<b>EASA</b>	<b>AIRWORTHINESS DIRECTIVE</b>	
	<p><b>AD No.: 2012-0192</b>  <b>[Correction: 24 September 2012]</b></p> <p><b>Date: 21 September 2012</b></p> <p>Note: This Airworthiness Directive (AD) is issued by EASA, acting in accordance with Regulation (EC) No 216/2008 on behalf of the European Community, its Member States and of the European third countries that participate in the activities of EASA under Article 66 of that Regulation.</p>	
<p>This AD is issued in accordance with EC 748/2012, Part 21.A.3B. In accordance with EC 2042/2003 Annex I, Part M.A.301, the continuing airworthiness of an aircraft shall be ensured by accomplishing any applicable ADs. Consequently, no person may operate an aircraft to which an AD applies, except in accordance with the requirements of that AD, unless otherwise specified by the Agency [EC 2042/2003 Annex I, Part M.A.303] or agreed with the Authority of the State of Registry [EC 216/2008, Article 14(4) exemption].</p>

<p><b>Design Approval Holder's Name:</b>  ATR-GIE Avions de Transport Régional</p>	<p><b>Type/Model designation(s):</b>  ATR 72-212A aeroplanes</p>	
<p>TCDS Number:</p>	<p>EASA A.084</p>	
<p>Foreign AD:</p>	<p>Not applicable</p>

Figure 1: Shock mount pick-up fitting potential failure

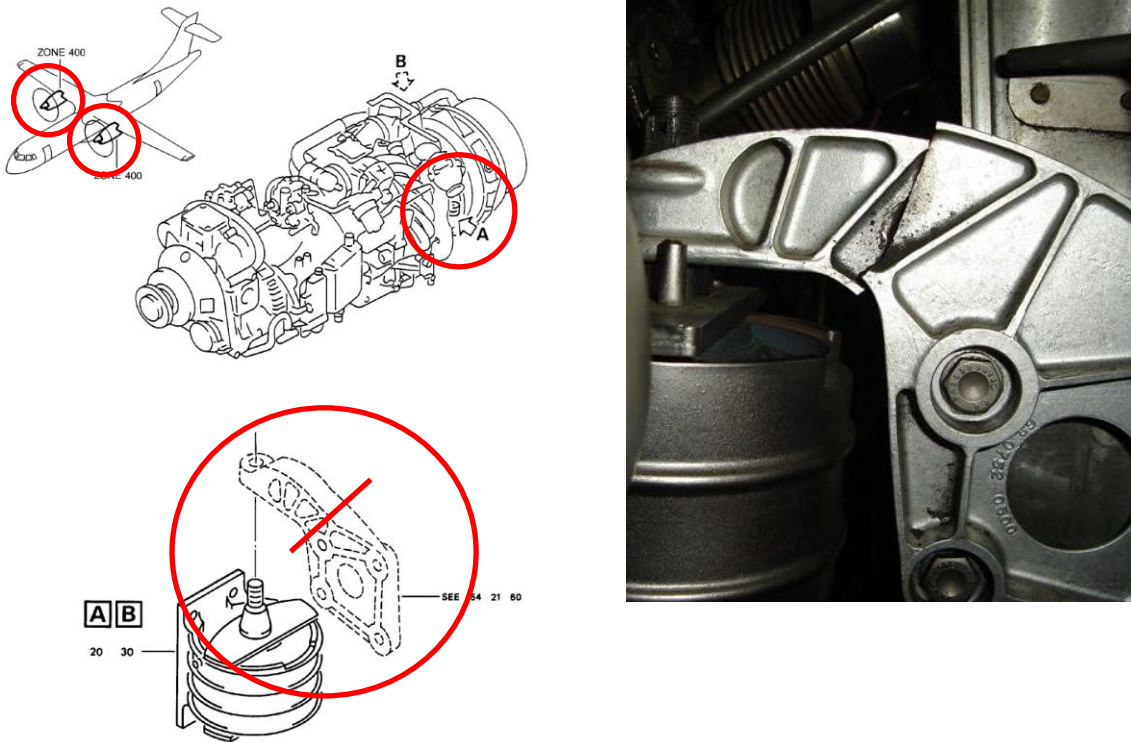
<p>Required Action(s) and Compliance Time(s):</p>	<p>Required as indicated, unless already accomplished</p> <p>(1) Within 6 months after the effective date of this AD, accomplish the following actions concurrently:</p> <p>(1.1) Identify the s/n of the P/N S54210394200 (Barry Control P/N 94423-05) LH and RH shock mount pick-up fittings installed on both engine nacelles. Appendix 2 of this AD identifies the fitting P/N and s/n locations.</p> <p>A review of maintenance records is acceptable to determine the s/n of the LH and RH shock mount pick-up fitting, provided the s/n can be conclusively identified from this review.</p> <p>(1.2) Visually inspect both LH and RH aft side isolator pick-up fittings on both engines in accordance with the instructions of the applicable Aircraft Maintenance Manual (AMM) Job Instruction Card (JIC) 541161-DVI-10000 paragraph 004.1. Refer to Appendix 1 Figure 1 of this AD for potential crack location.</p> <p>(1.3) Visually inspect both LH and RH aft shock mount cone bolts on both engines in accordance with the instructions of the applicable AMM JIC 712000-DVI-10000 paragraph 006.3.A. Refer to Appendix 1 Figure 2 of this AD for potential crack location.</p> <p>(2) If, during any inspection as required by paragraphs (1.2) or (1.3) of this AD, cracks are detected, before next flight, replace defective component in accordance with approved ATR instructions.</p> <p>(3) If the s/n of the L/H shock mount pick-up fitting, identified as required by paragraph (1.1) of this AD, is lower than 2451 or unreadable, and no crack has been found, within 6 months after the inspection as required by paragraph (1.2) of this AD, replace LH shock mount pick-up fitting P/N S54210394200 with a serviceable LH shock mount pick-up fitting having a s/n equal to or higher than 2451, in accordance with ATR approved instructions.</p> <p>(4) Within 30 days after the inspections as required by paragraph 1 of this AD, report all findings (including none) to ATR, by using the reporting form provided in Appendix 3 of this AD.</p> <p>(5) From the effective date of this AD, do not install on any aeroplane a LH shock mount pick-up fitting P/N S54210394200, unless it has been determined to have a s/n equal to or higher than 2451.</p>
